TECHNICAL INFORMATION

No: 76/21/99/NAS
 Ref:
 Issue: 1
 Date: 07/16/99

Front Seat Recline Trim Piece loose

DISCOVERY Series II (LT) Up To XA902786
 Up To XA206760

Figure 1

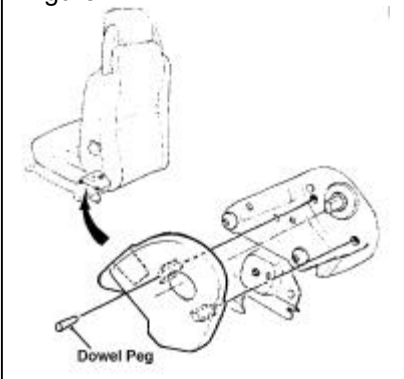
FRONT SEAT RECLINE MECHANISM TRIM PIECE EXHIBITS POOR FIT.

A customer may complain of a loose or misaligned trim piece on the seat recline mechanism. This may be due to insufficient fastening of the trim piece to the seat frame.

A new trim piece has been developed with a dowel peg fastener to ensure proper fit. These new specification components are factory installed on all vehicles produced after the above vin ranges, and can be fitted to earlier vehicles to correct fit problems.

1. Adjust the seat to its rear-most position.
2. Remove the recline mechanism trim piece by pulling it away from the two stud locations in the seat frame.
3. Install the new specification trim piece as follows:
 - Locate the trim piece retaining studs.
 - Push the trim piece into the seat frame.
 - Insert the tapered dowel peg into the forward retaining stud, and press firmly.
